APPEAL SUMMARY

Status: Decision Rendered	
Appeal ID: 16103	Project Address: 515 NE Holladay St
Hearing Date: 11/8/17	Appellant Name: Calista Fitzgerald
Case No.: M-001	Appellant Phone: 503-265-1535
Appeal Type: Mechanical	Plans Examiner/Inspector: Thomas Ng
Project Type: commercial	Stories: 12 Occupancy: Construction Type:
Building/Business Name: Grand Avenue Apartments	Fire Sprinklers: Yes - entire building
Appeal Involves: Erection of a new	LUR or Permit Application No.: 17-204636-MT
structure,Reconsideration of appeal

APPEAL INFORMATION SHEET

Appeal item 1

LEVEL 2 - FLOOR PLAN

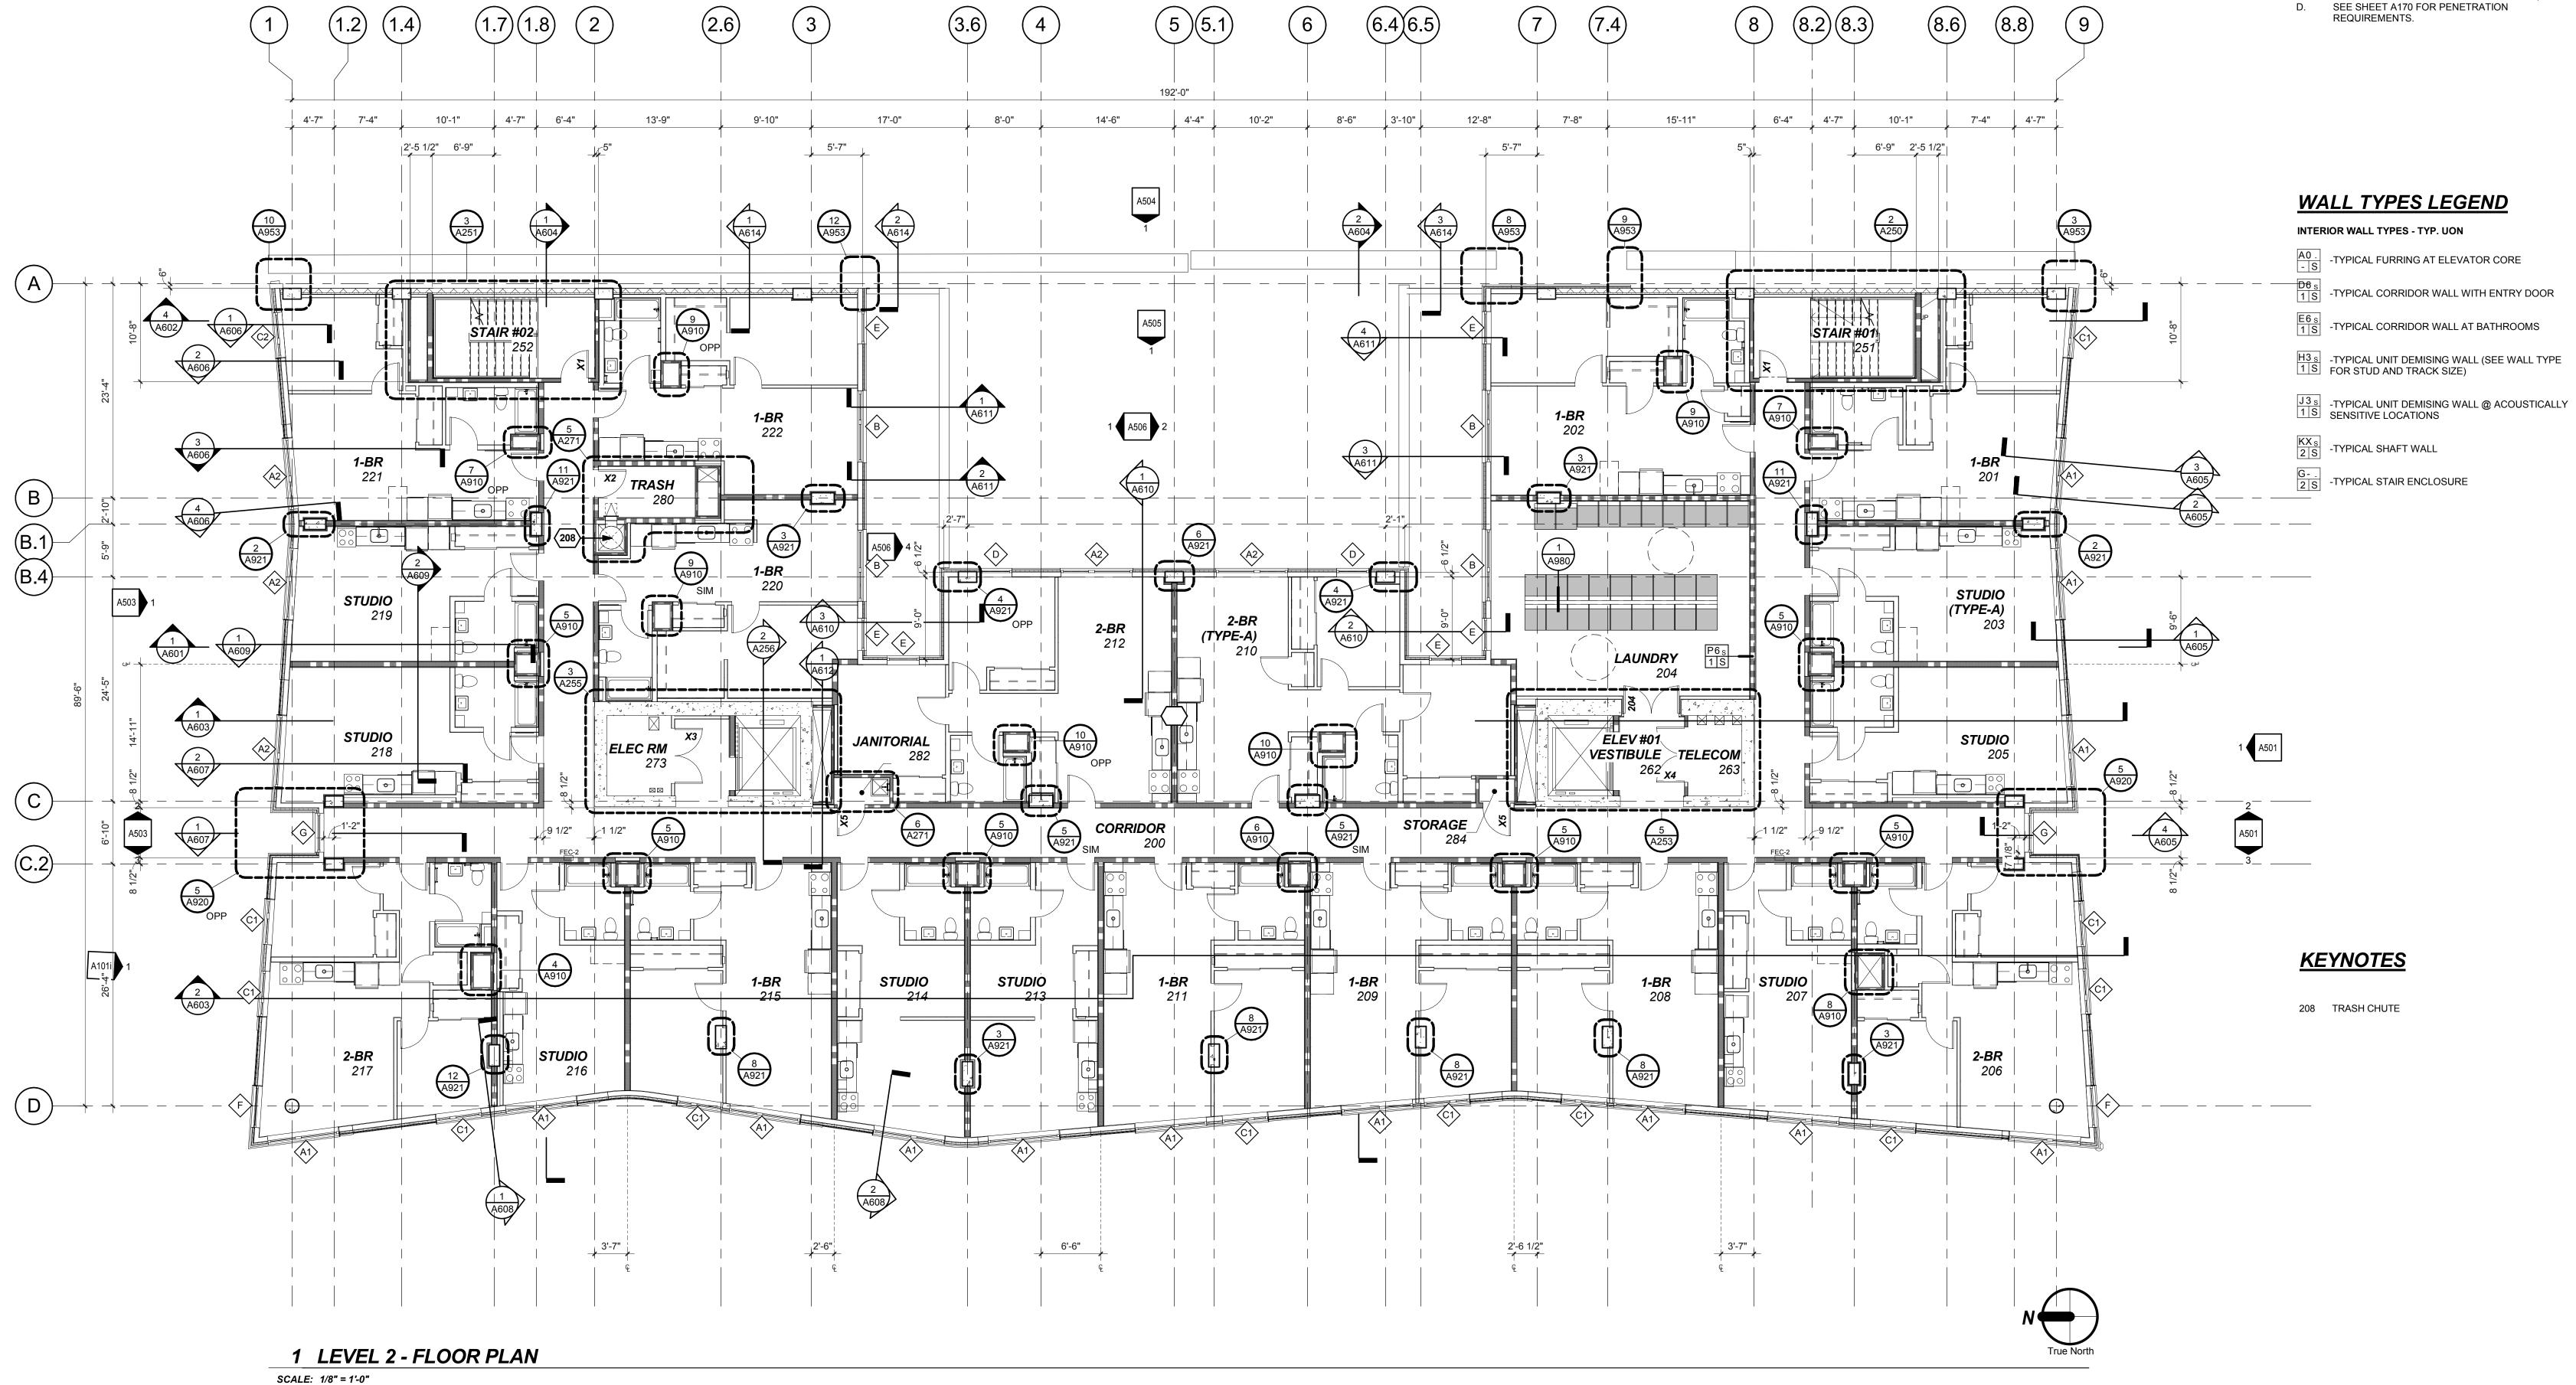
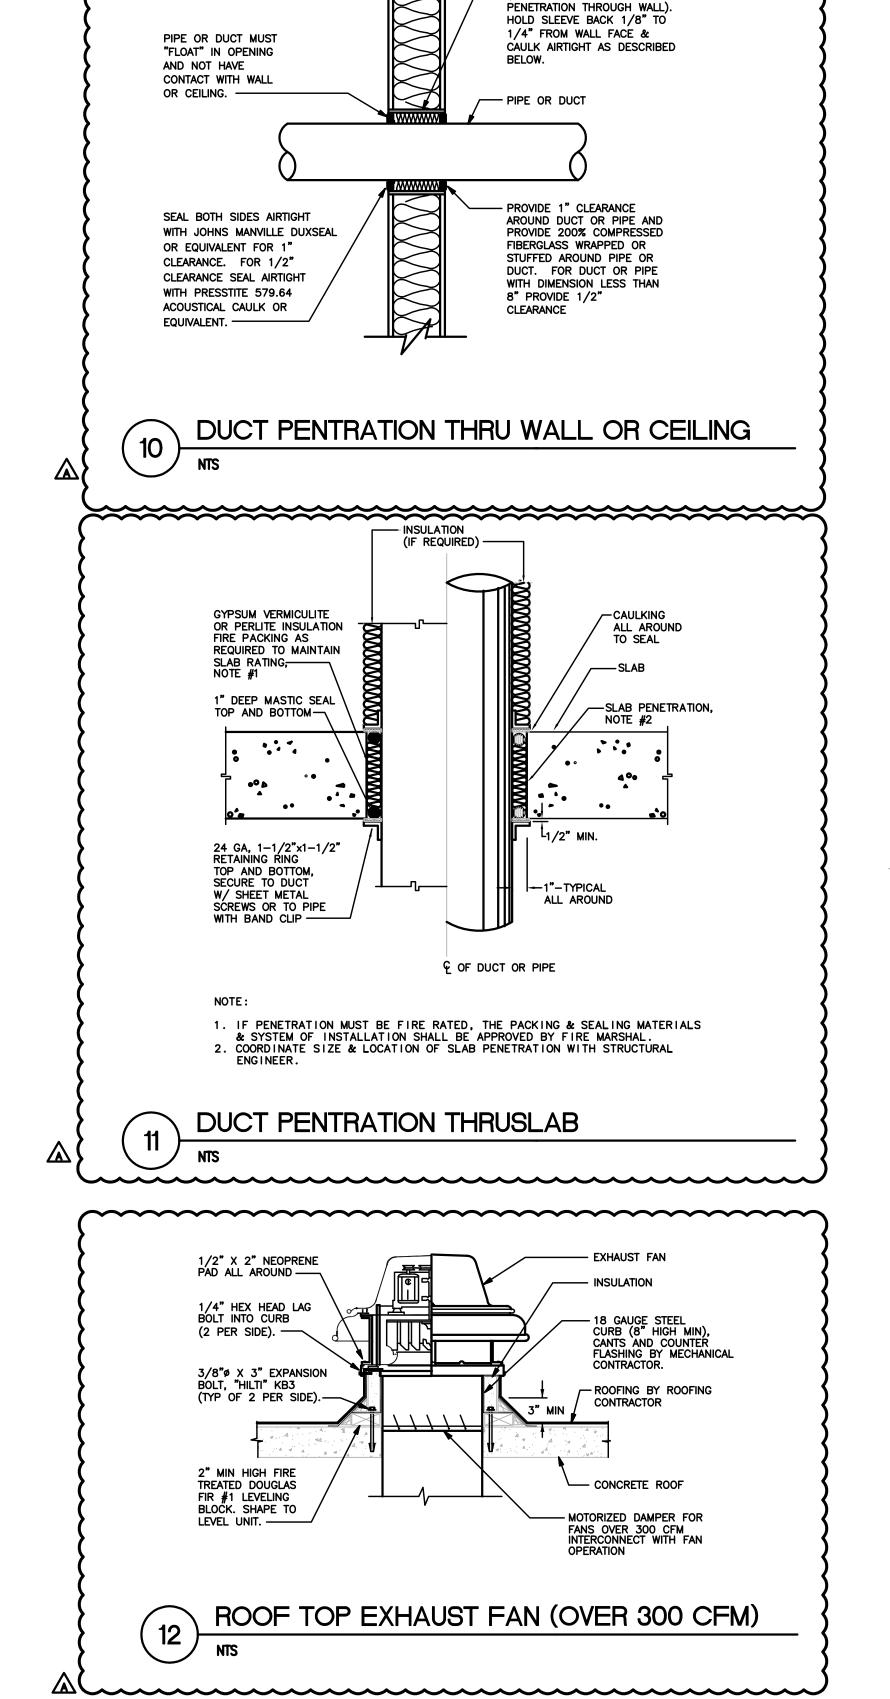
The proposed design will meet the requirements of OSMC 505.1, except the kitchen exhaust and bathroom exhaust will combined to use a subduct system per OSMC 607.5.5, exceptions 1.1 and 2 and the dryer exhaust from each unit will be combined into a separate subduct system per OSMC 607.5.5, exceptions 1.1 and 2

Equivalent protection is provided for the 2 separate subduct systems by the following:

Rigid 26 ga. min. metal subducts extending 22" min. above shaft penetration.

Continuous vent fan at the top of the shaft.

Continuous vent fan provided with emergency power for the shaft with the kitchen exhaust. Continuous vent fan provided with emergency power for the vertical dud with the dryer exhaust.

The kitchen/bathroom subduct system will be into the shaft space per OSMC 505.3.

Dryer exhaust will be provided in separate 26 ga. min. vertical duct. Dryer exhaust from each unit will have 26 ga. metal duct that extends into the vertical duct and extends 22 inches minimum into the vertical duct. The duct will be provided a fire rated access panel at each level.

See 9/M602 and A202 attached.

Domestic range hoods and bathroom exhaust to share common airstream as part of a subduct exhaust system: Granted as proposed.
